Author: Laura Andrade Procurement Department		Page 1/4 Status: Live
Issue: 3	Clarifications Register Tender 9840 Design and Build Enabling Works at the DART+ and MetroLink Interface at Glasnevin	Date: August 2026

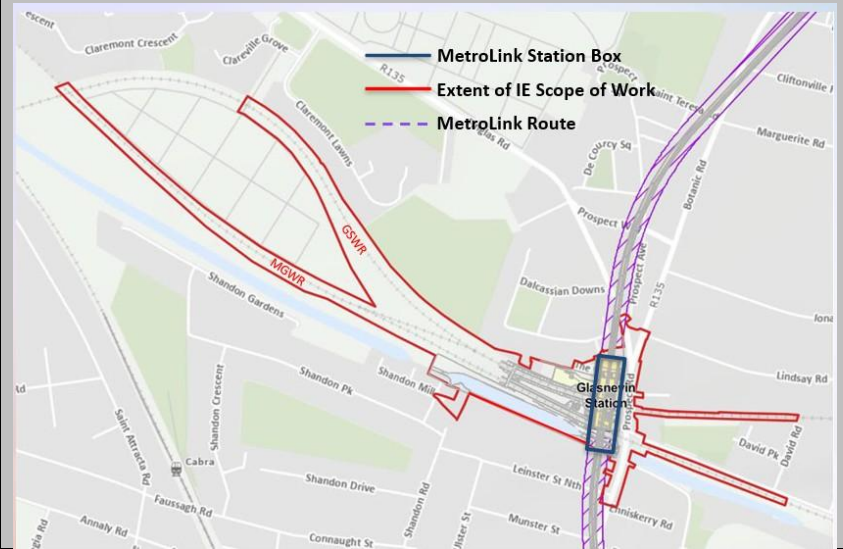
2.	Scope Clarification	23/07/2026	Following consultation and agreement with MetroLink, IÉ confirm that the scope split between the MetroLink works and the IÉ 9840 works is as follows: MetroLink M140/M401/M500 Contracts • Street level building demolition works • Third party utility diversions/decommissioning (in relation to street level buildings that are to be demolished and diversion of utilities sufficiently away from the M401 station box/worksite area). • Construction of the station box/diaphragm walls including street-level structural slabs; and MetroLink tunneling works. • Construction and installation of all urban realm landscaping, highways and street furniture infrastructure at street level. IÉ Contract 9840: • All civil and structural works outside of the station box footprint as listed, but not limited to, Section 1.1 of the PQQ. The IÉ 9840 tender comprises the design and build of the IÉ enabling works at the MetroLink/DART+ interface, which are required to facilitate the construction of the MetroLink station box. The contract interfaces with MetroLink at the station box boundaries, with all heavy civils works within the station box, including associated tunneling works, forming part of the MetroLink M401 scope. Accordingly, the

works included within the IE 9840 scope at Glasnevin will be descoped from the ML M120/M401 ITT. Refer to Figure below detailing scope split. 
3.	Tender Value	23/07/2026	Following clarification of scope split with MetroLink the estimated value of the tender has been revised downwards to €200 million. This estimate is based on the IE's preliminary estimates of works that may be procured under this tender and represents the IE's best estimate of the anticipated total value of contract. Given the variable demand for the works that may be procured, the estimated value should not be taken as a definitive indication or guarantee of the volume of works
